BID # 02-220518

DISTRICT WIDE SEAL & STRIPE PROJECT – EAST SIDE
VICTOR ELEMENTARY SCHOOL DISTRICT
VICTORVILLE, CA

May 13th, 2022

ADDENDUM – 02

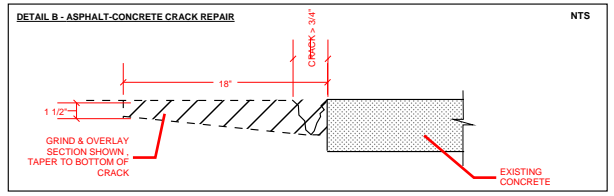
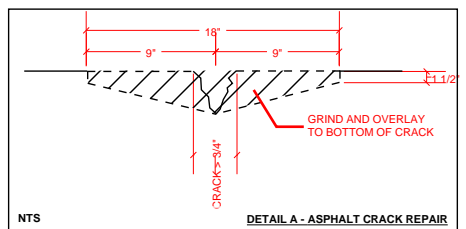
ITEM NO. 6 Question: Project Manual, Minimum Asphalt Specification Item 1b notes that for Cracks greater than 3/4 inch a minimum of 2 inches is to be cut on each side of the crack. General note No.3 states contractor is to follow Detail A which provides an 18 inch section. Please advise how to proceed.

Contractors to follow Detail A & B as it applies per General Notes for repairs of cracks greater than 3/4 inch.

DEL REY ELEMENTARY SCHOOL

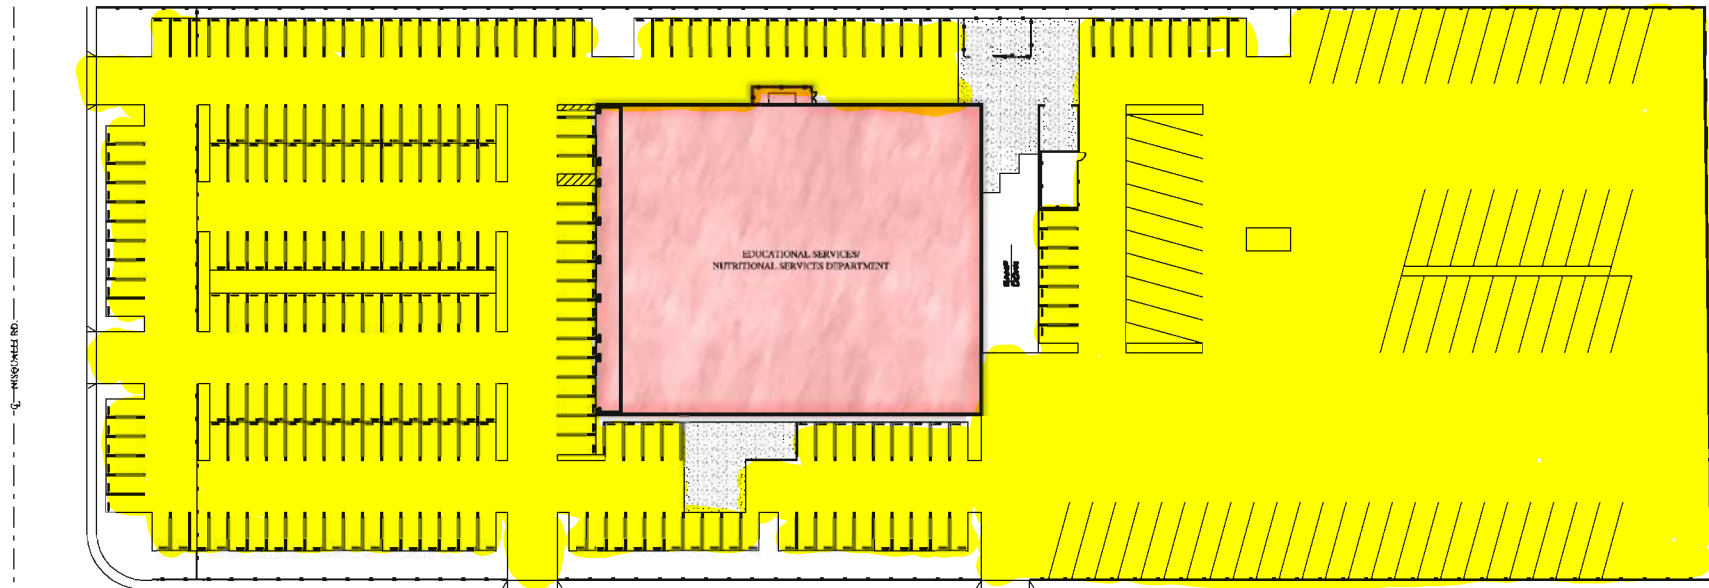
- Special Conditions
1. Include new asphalt between Portables 30, 31 & 32.

GREEN TREE EAST ELEMENTARY SCHOOL

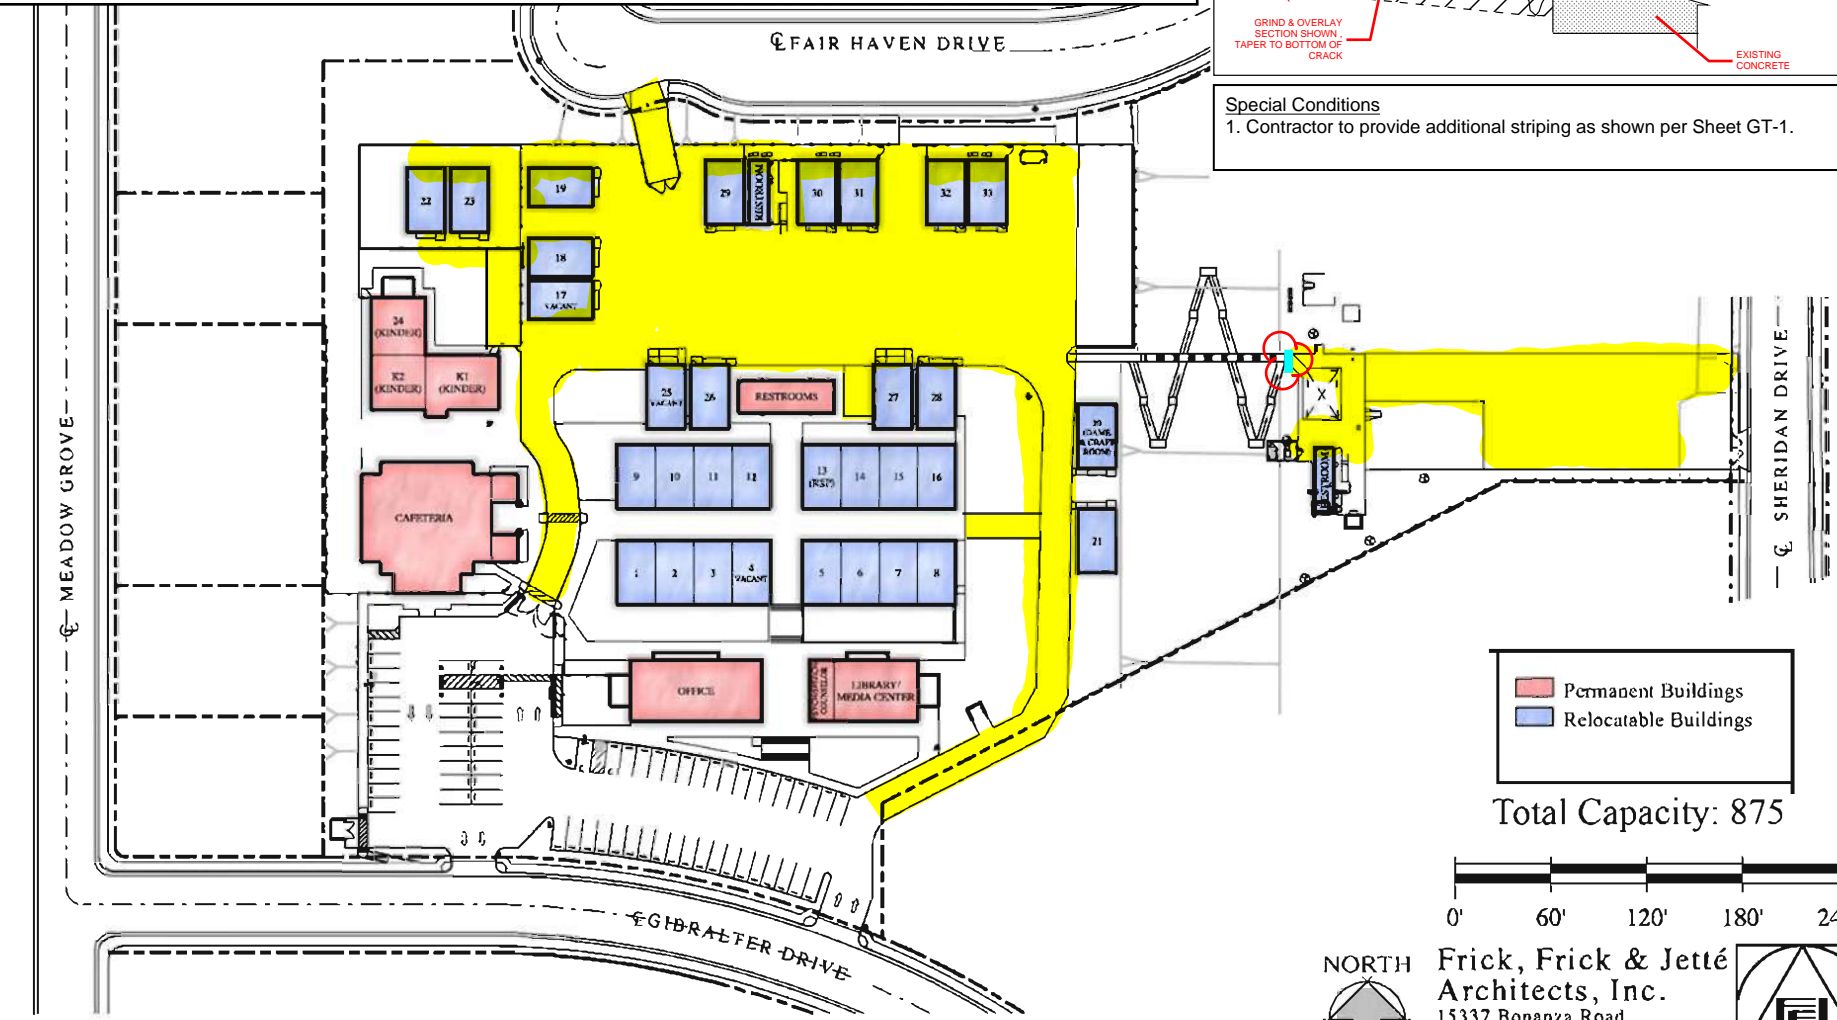
1. Contractor to provide additional striping as shown per Sheet GT-1.

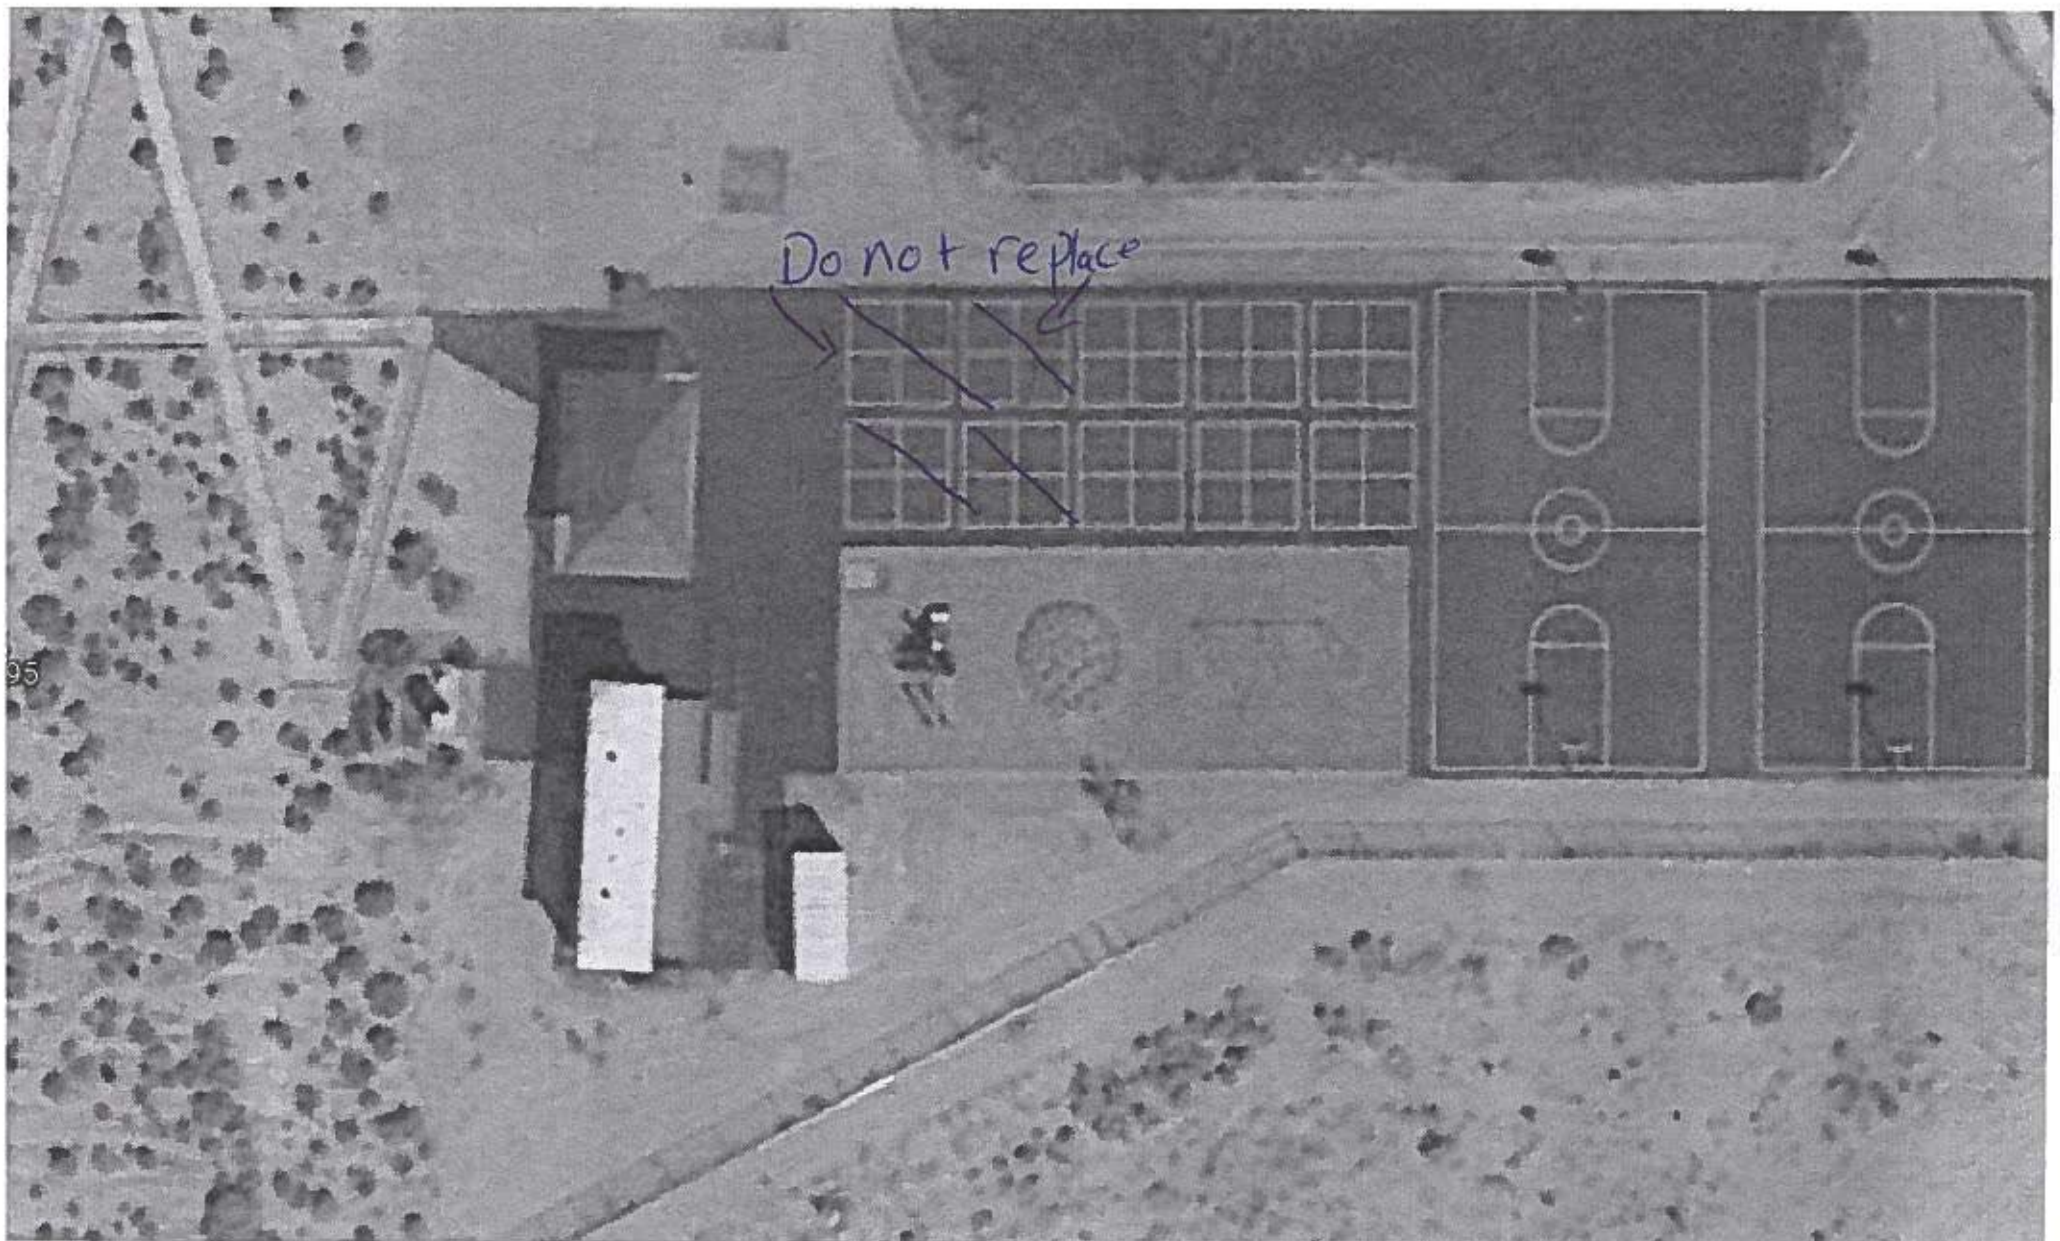
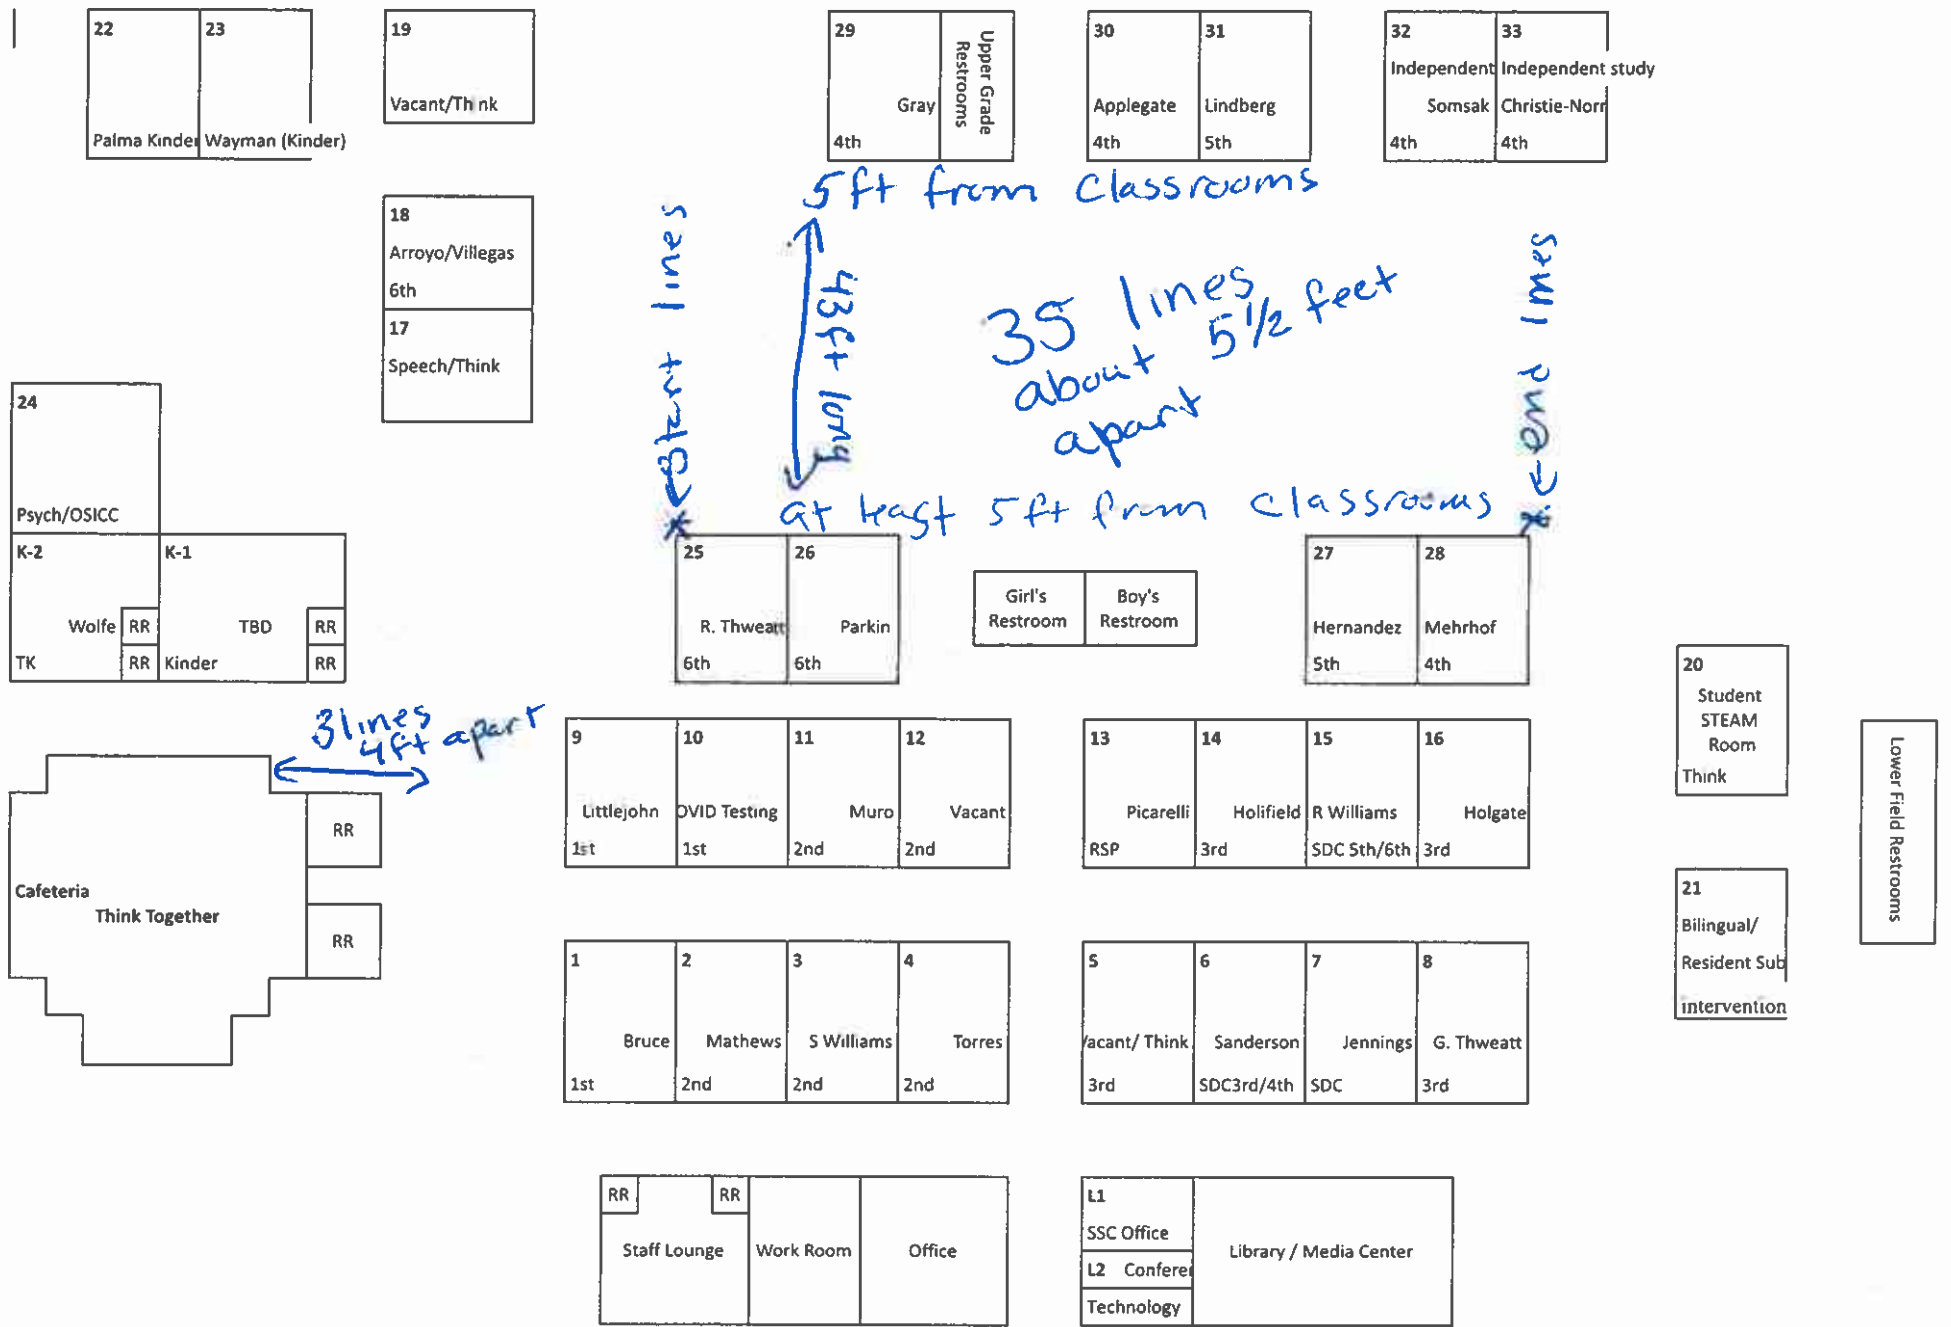
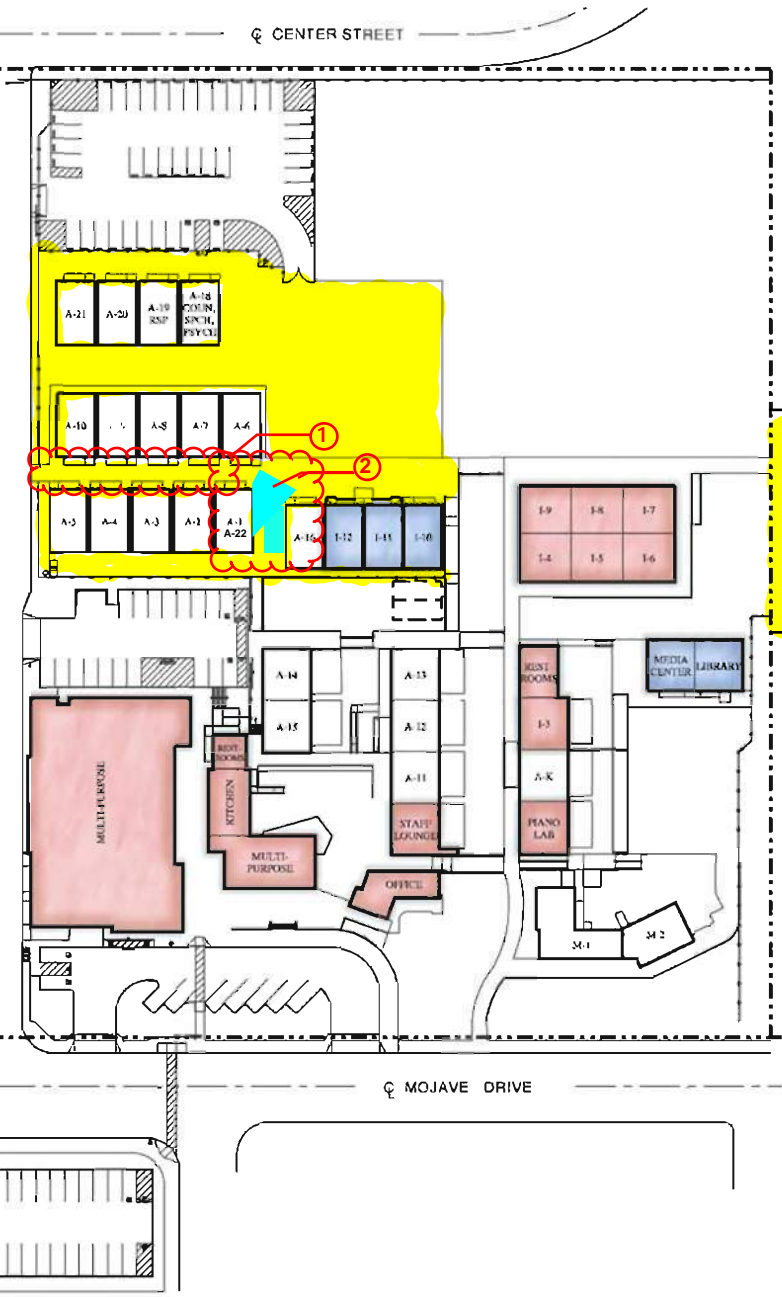
Lower playground
 when you repaint please only replace 6 of the 10
 hard 4 square courts.

- ① Striping between walkway spanning between portables A-6 - A-10 to exclude arrows.
- ② Area to be lifted to assist in drainage. High points at this area to be ground.
